ADDENDUM NO. 2

CONTRACT NO. 19-514

Low Rise Building Renovations and HVAC Improvements
110 Dr. Martin Luther King Jr. Boulevard
White Plains, New York

1 IT ROOM PART PLAN - WEST WING
E.104 1/2"=1'-0"

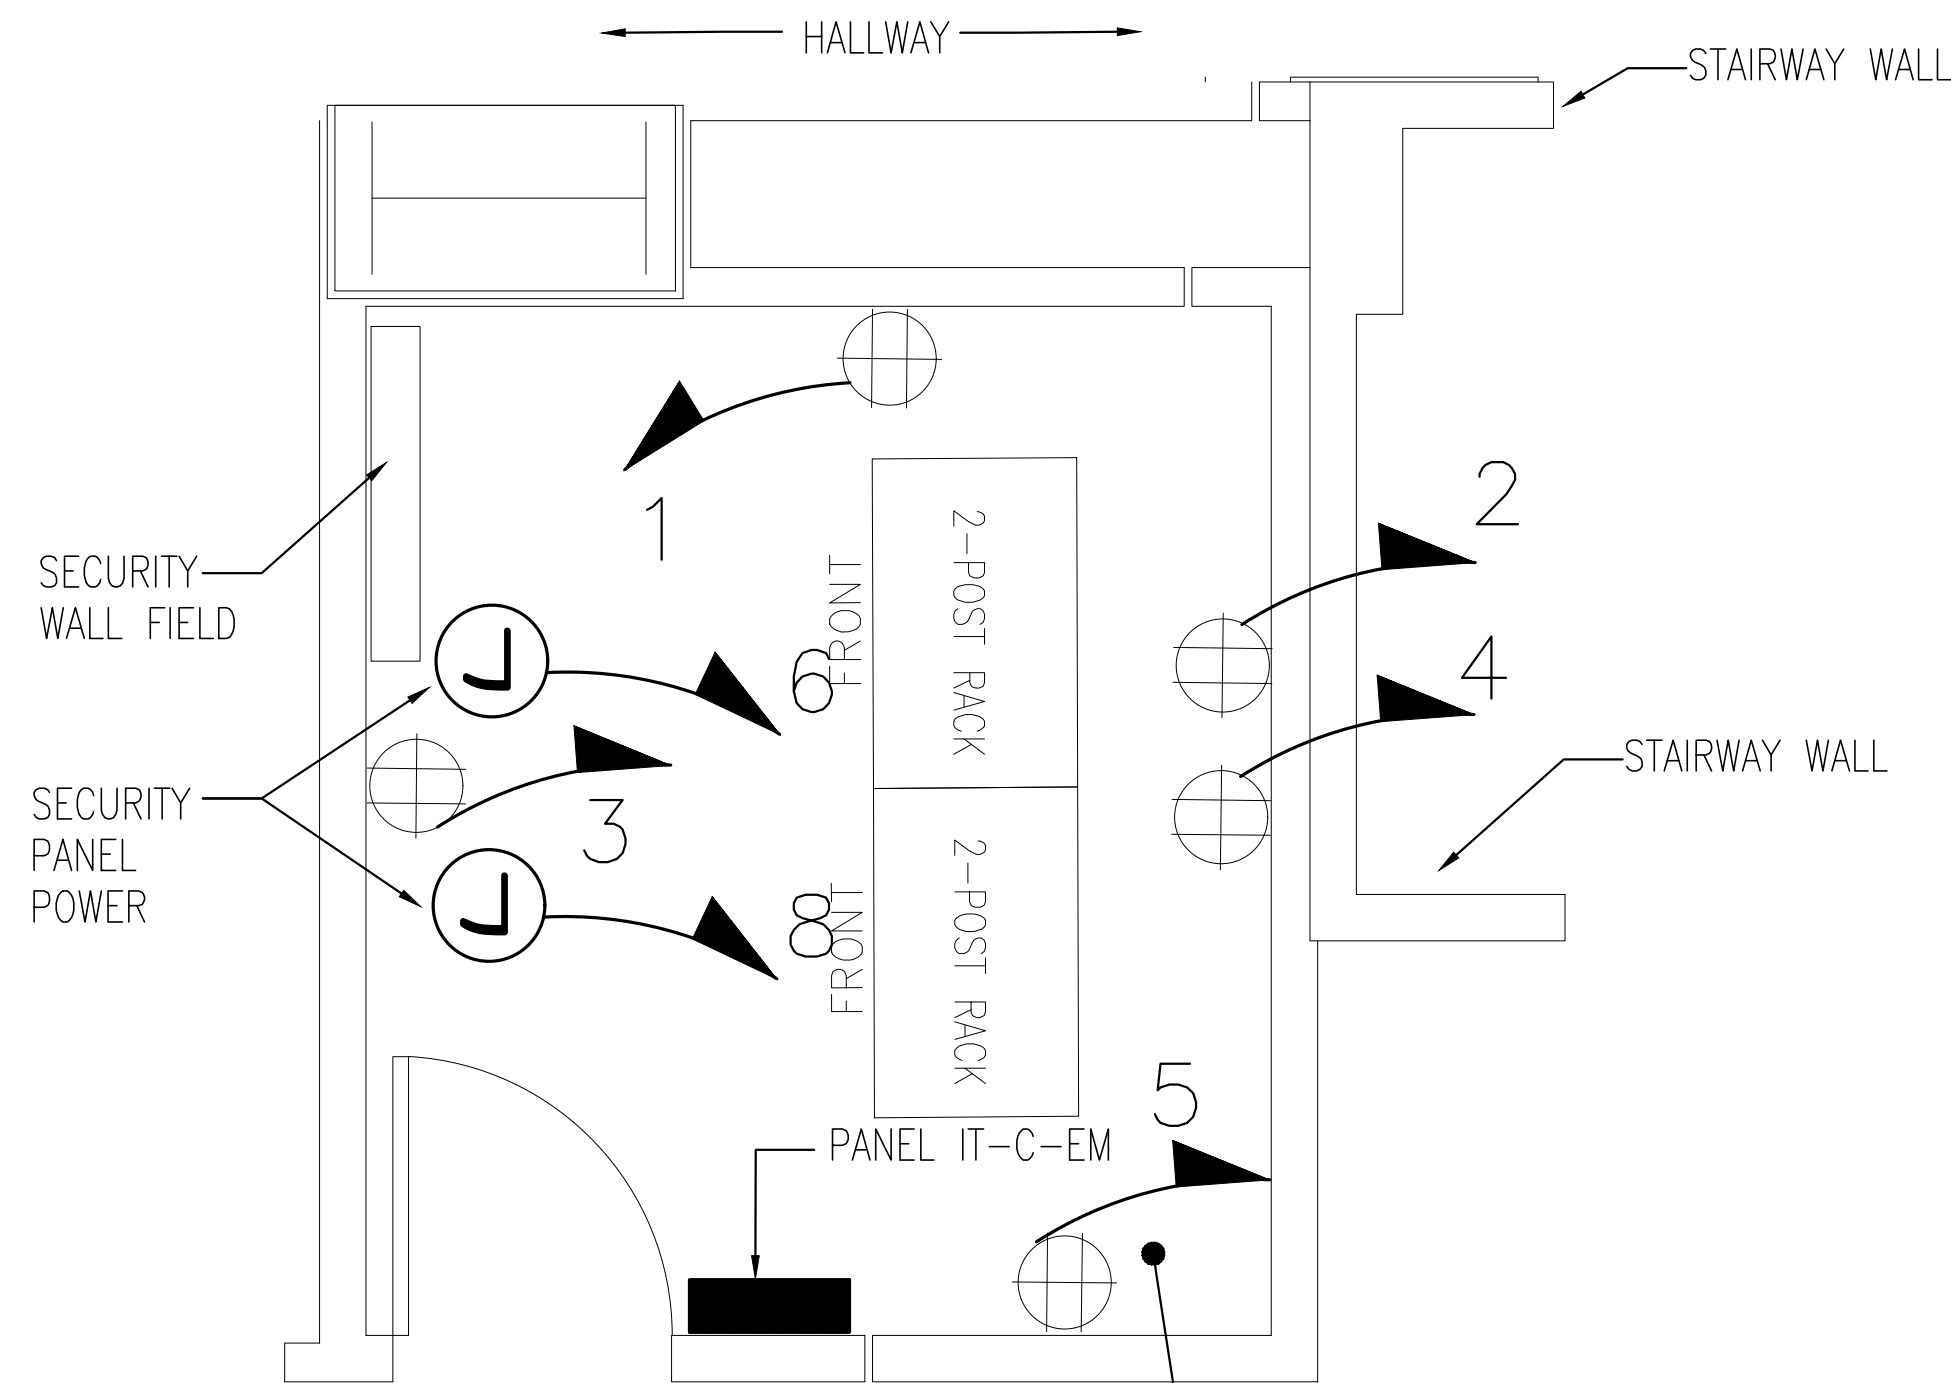
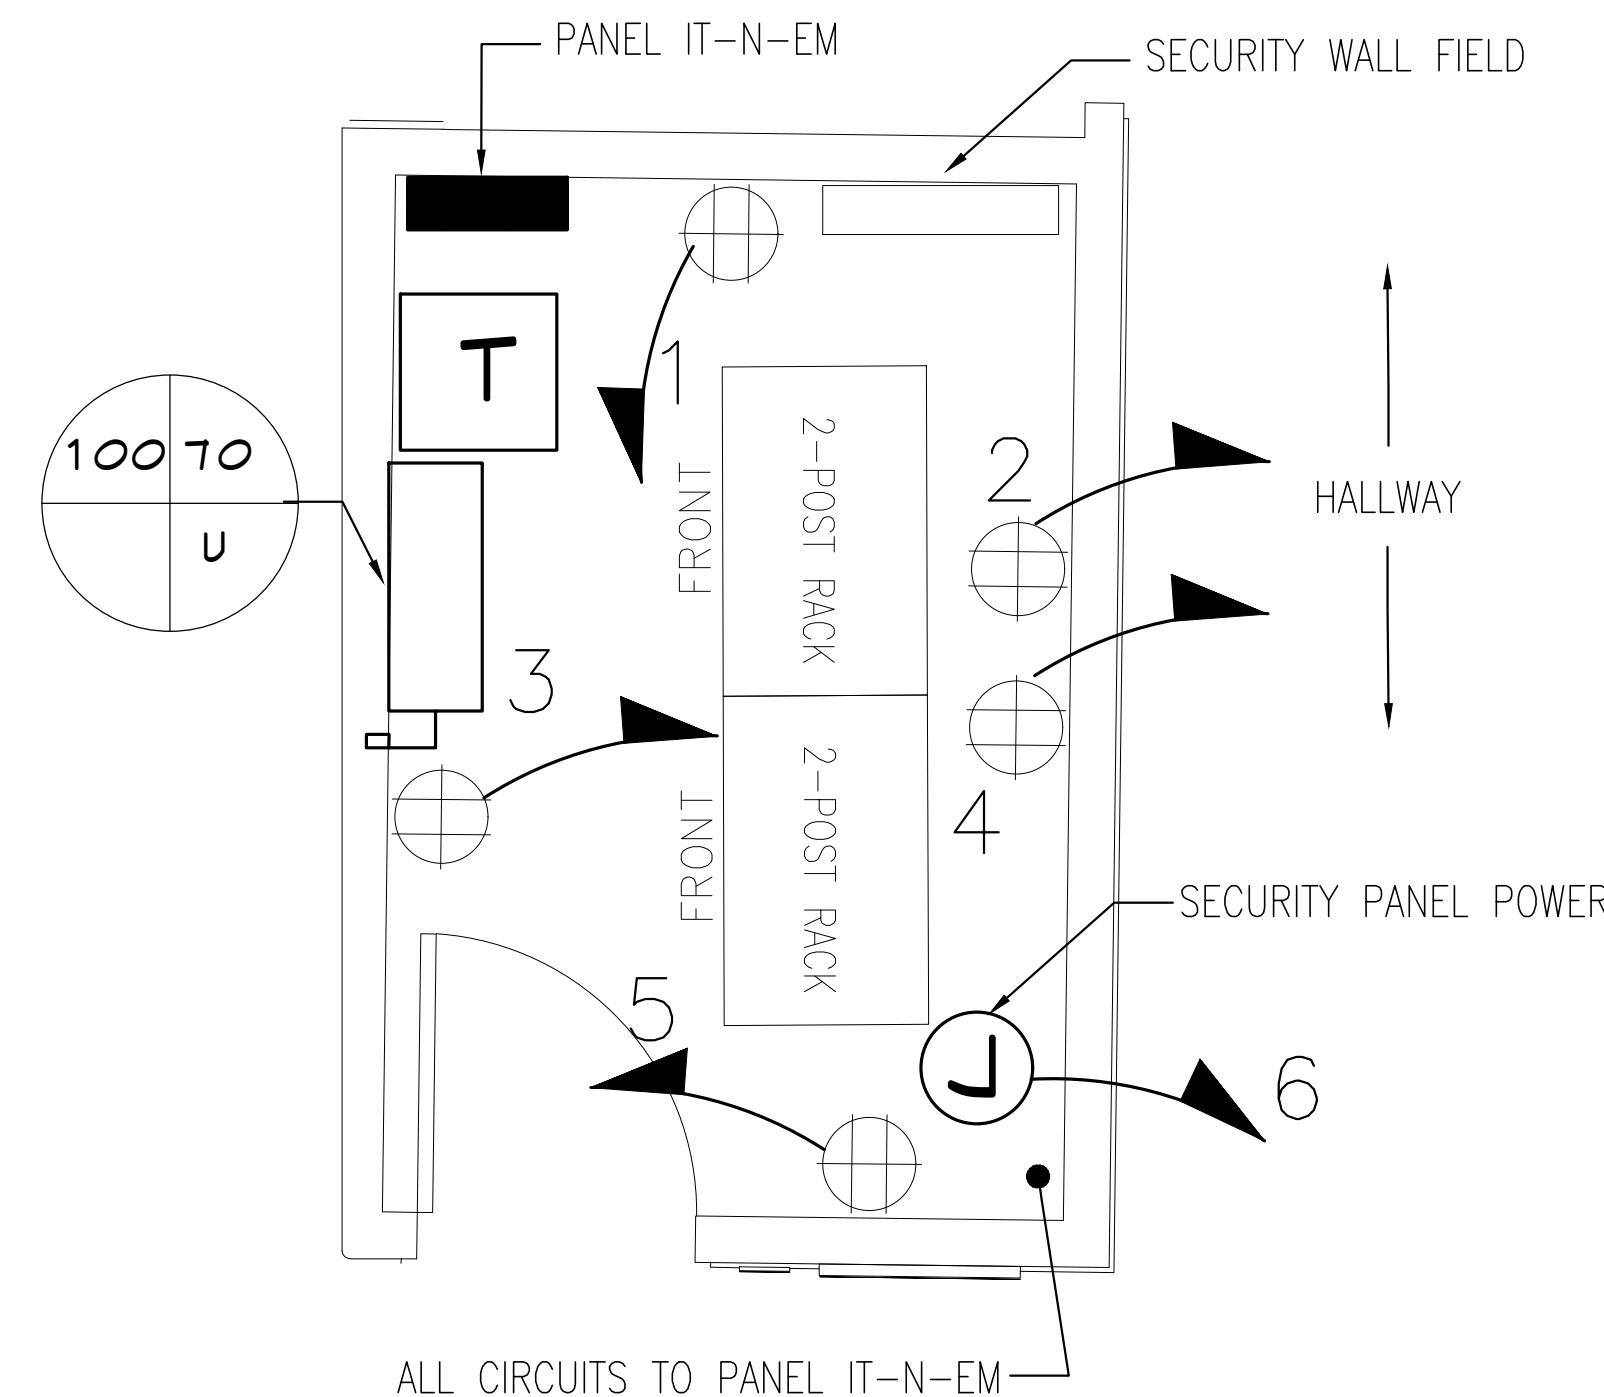
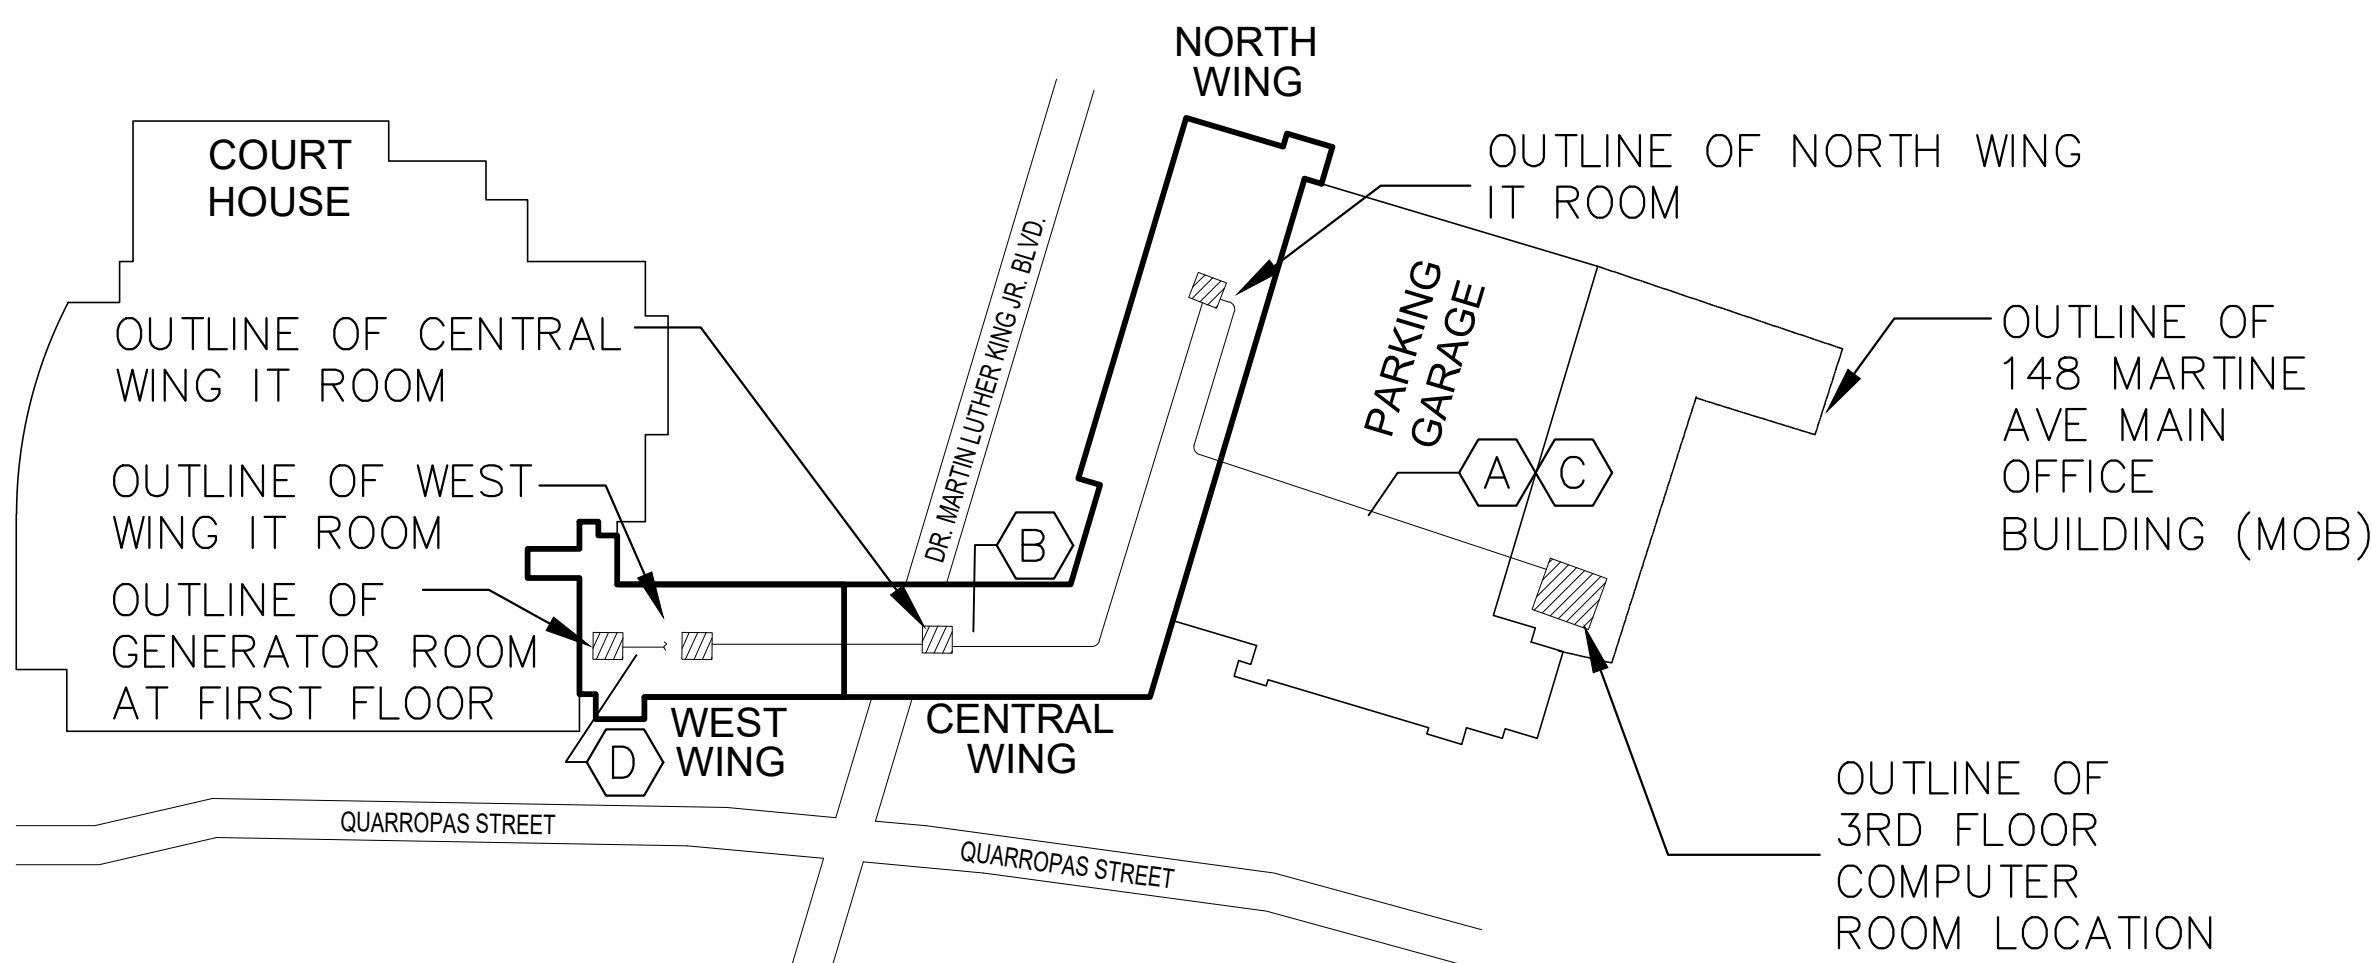
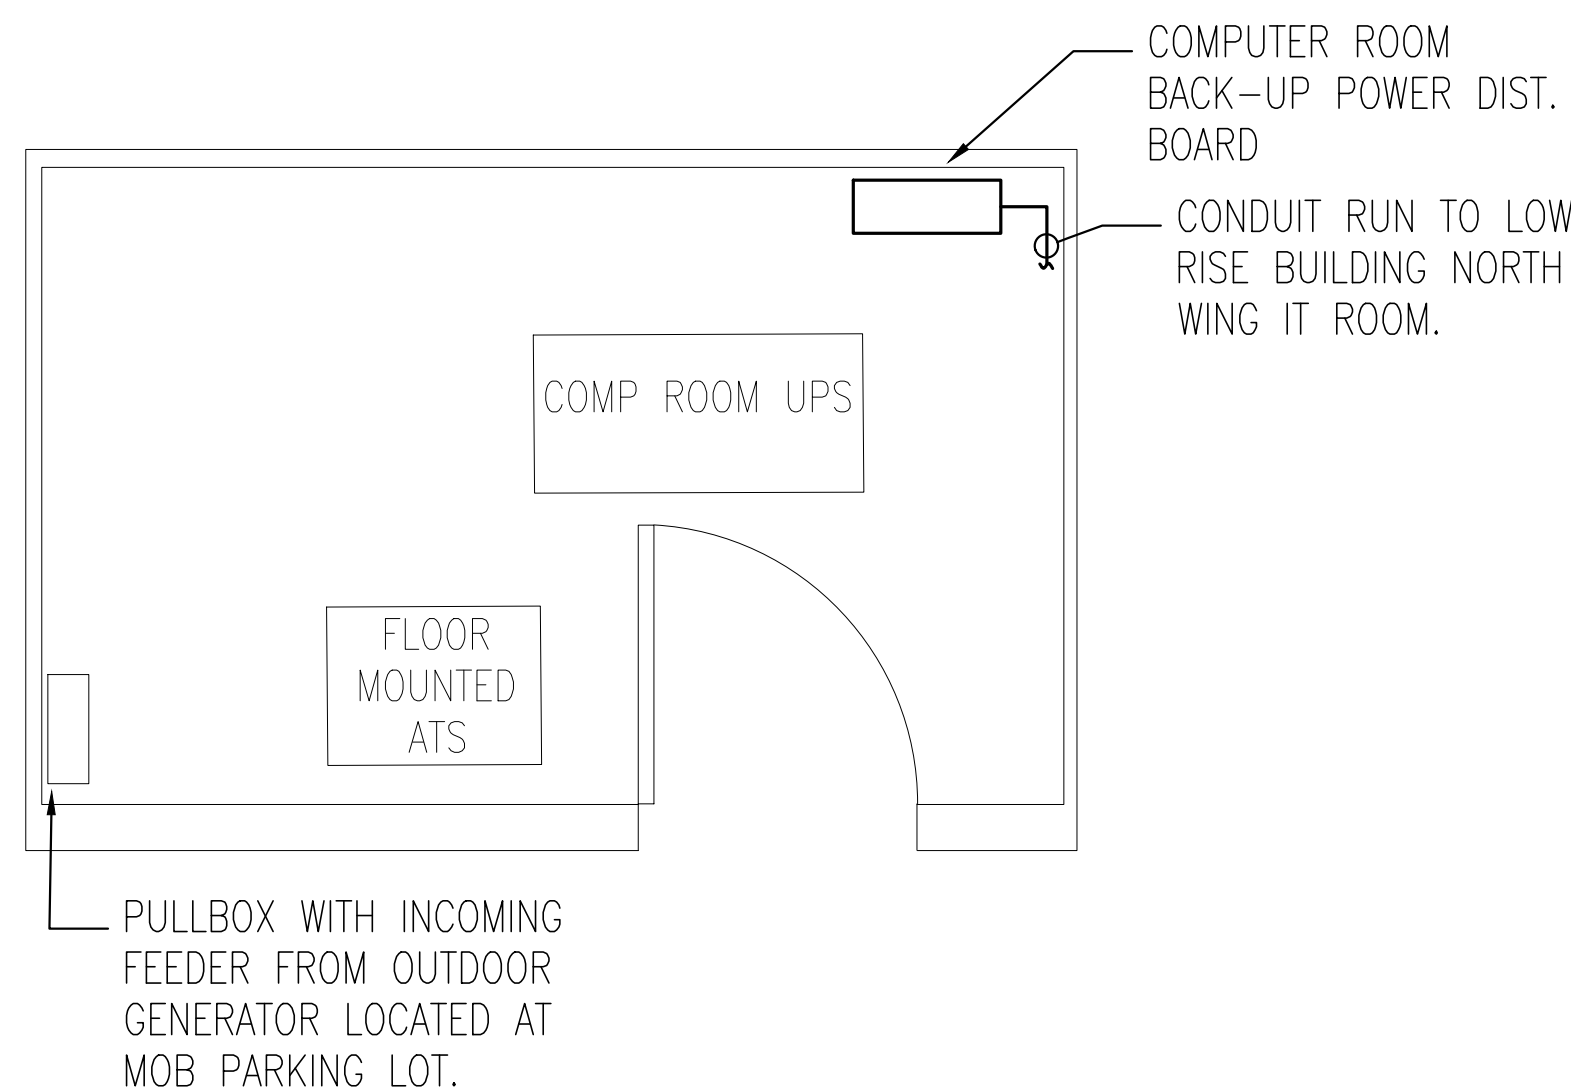
E-104: Emergency power feeder provided from Main Office Building Computer Room to serve Low Rise IT Room panels. Added emergency panel and circuits in each low rise IT room to serve network equipment
